In regards to the rear unit and the boundary wall of the rear garage. We are happy to remove the garage and leaving the rear unit setback 6.3meter from the side boundary.

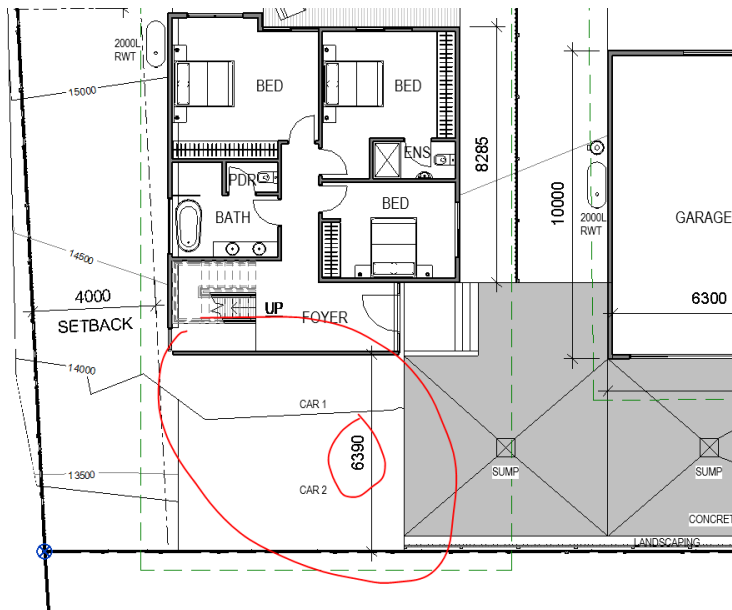
In regards to the front unit, it was designed to comply with the building envelope. Information of the shadow diagram provided in the planning application set has illustrated that the habitable rooms (other than bedrooms) and its private open space of the adjoining unit is located on the south east corner. Under the planning scheme, these are the areas that of concern and was not affected by the development. The shadow has implication to the bathroom and bedroom. See attached for clarification and I trust this is sufficient to demonstrate.

Note that, the geographic of the site has naturally overshadow all the lower lot because the nature ground has slope up from west to north. The adjoining future development up north will also overshadow to this development. this is unavoidable. Moreover, the front unit develop within the permitted height and building envelope.
